Addendum No. 2
February 26, 2021

Project: Lincoln High School – C.I.P. Addition and Renovations PD#3311
Sioux Falls, South Dakota

9.11

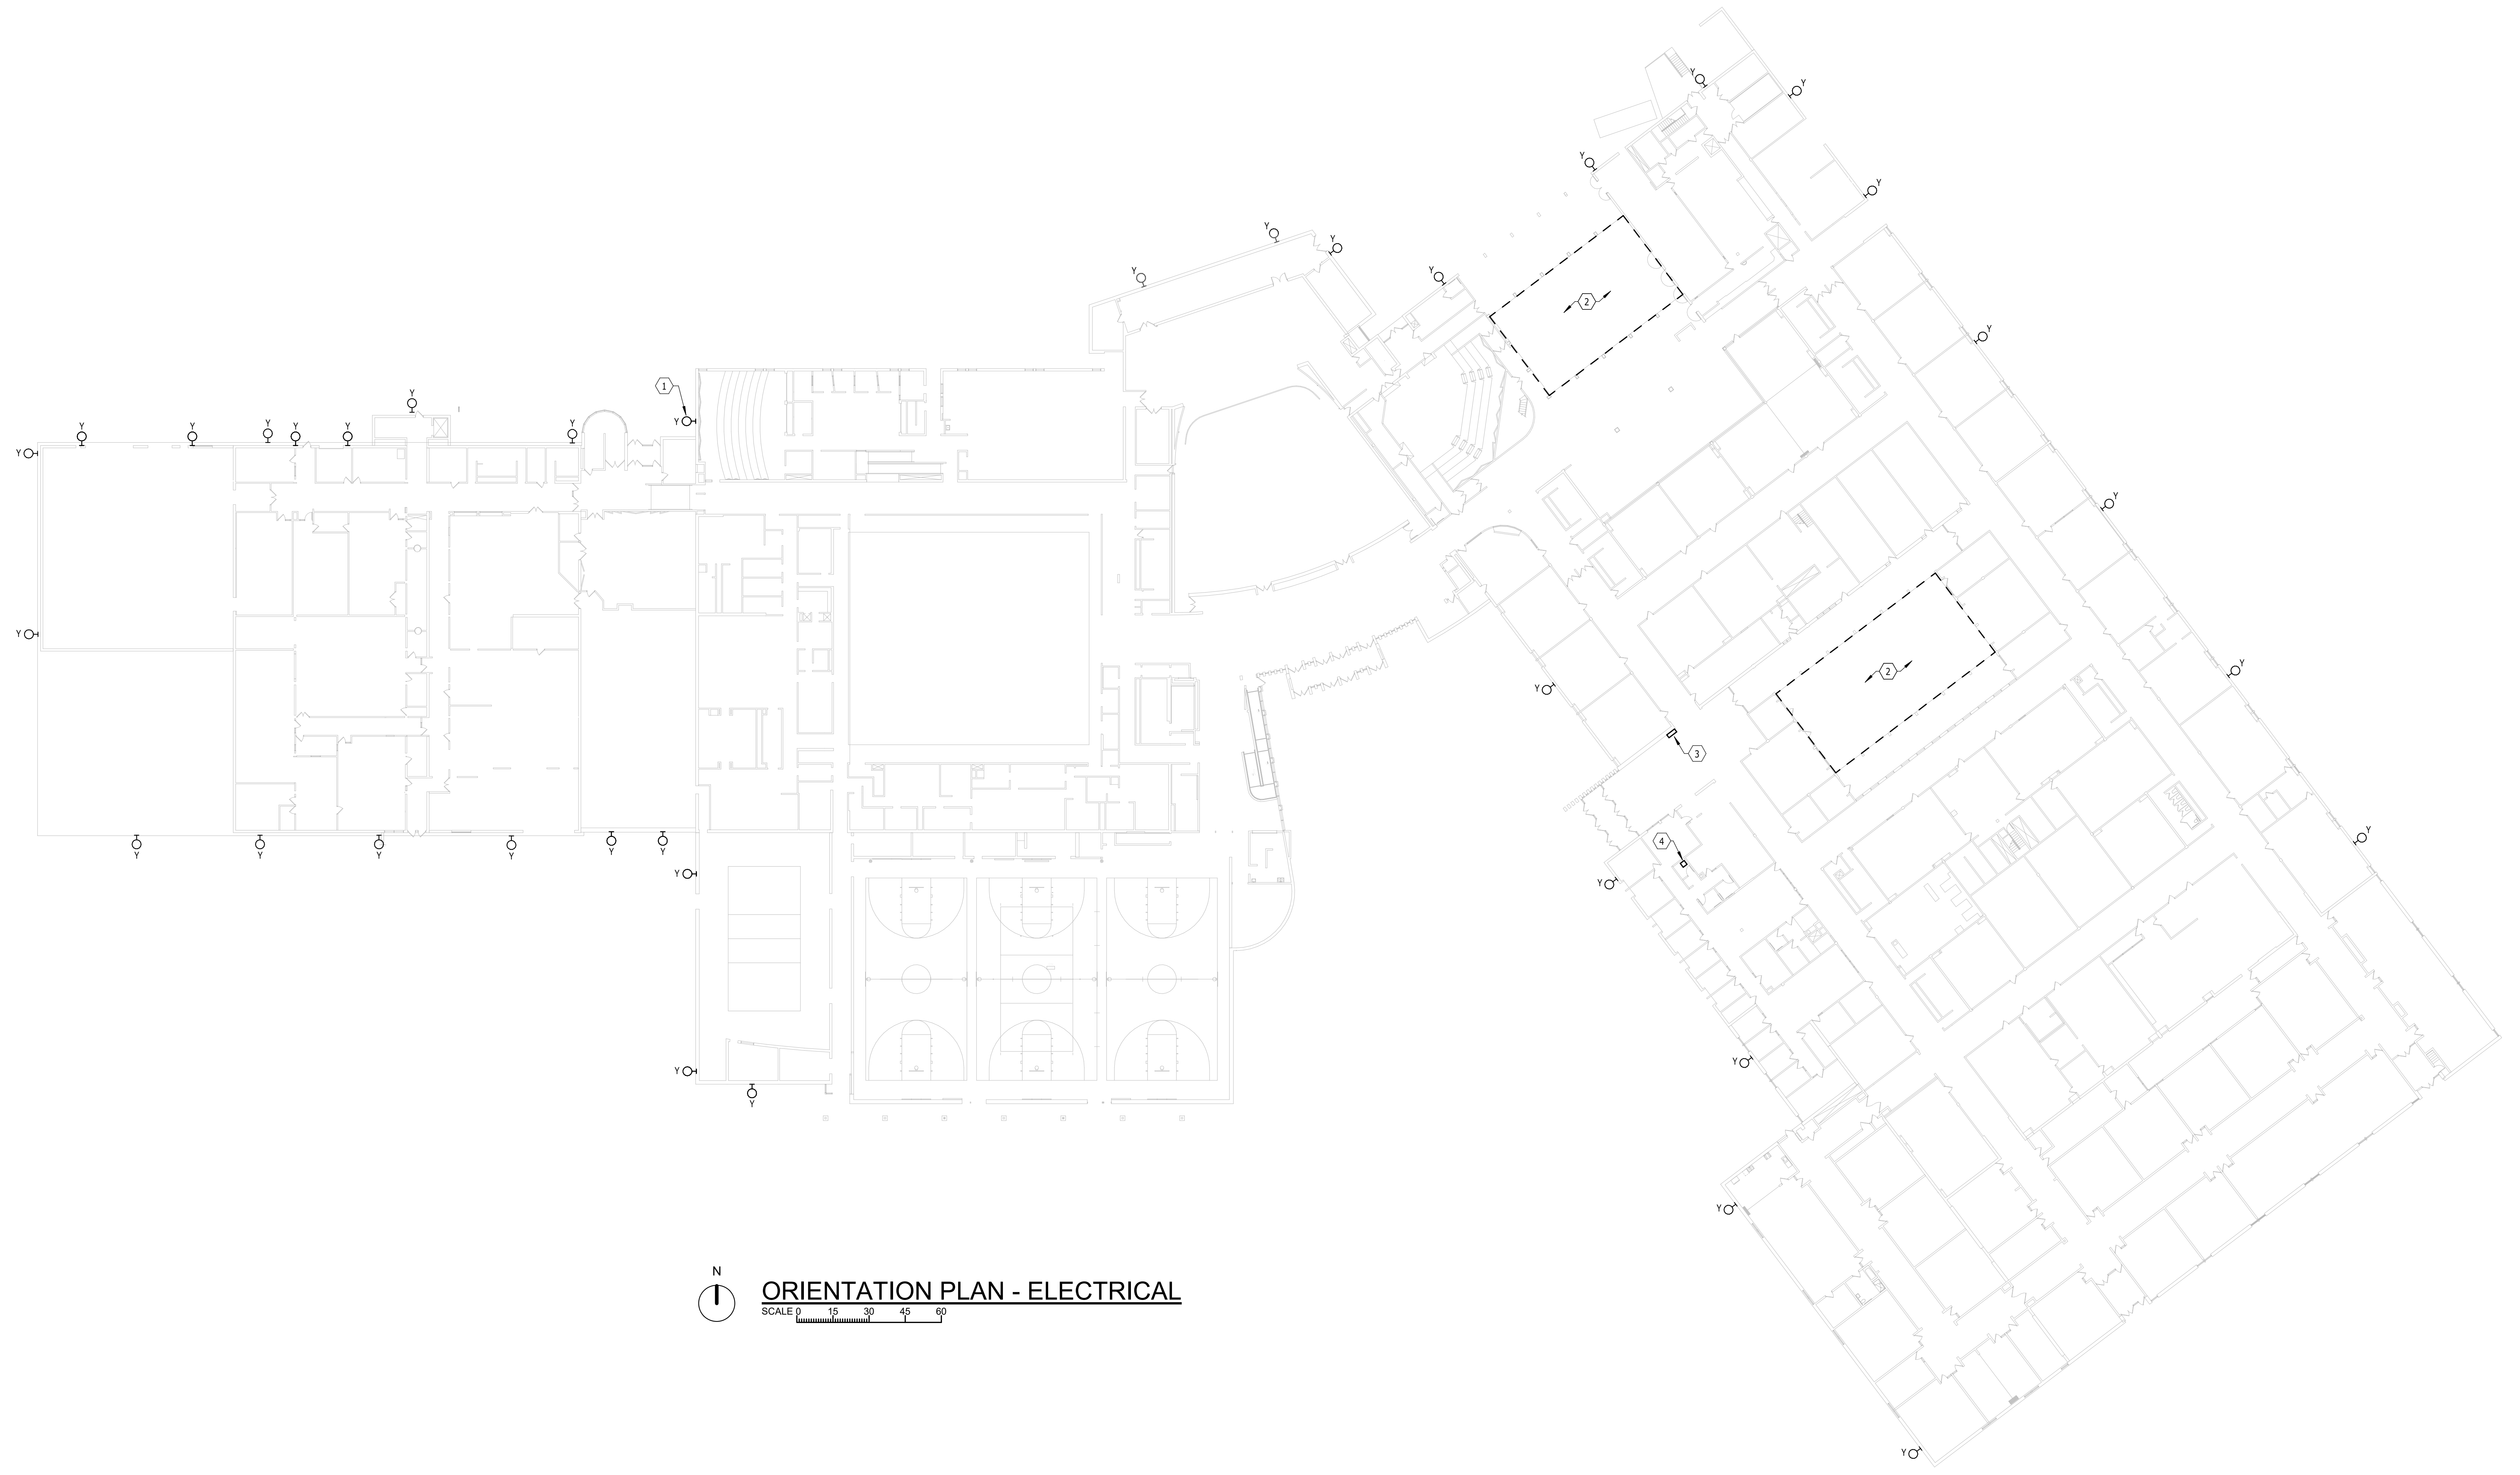
- a) Reference new Electrical Notes 3 & 4 regarding existing fire alarm control panel & intercom system equipment rack locations on revised electrical drawing Sheet 9.11, revision dated 2-26-21, attached to the end of this addendum.

- 1 REMOVE EXISTING WALL-PACK LUMINAIRE, REPLACE WITH NEW, TYPICAL.
- 2 SEE SHEET 9.38 FOR ELECTRICAL WORK IN THIS AREA.
- 3 EXISTING FIRE ALARM CONTROL PANEL (FACP).
- 4 EXISTING INTERCOM SYSTEM (BOGEN) EQUIPMENT RACK.
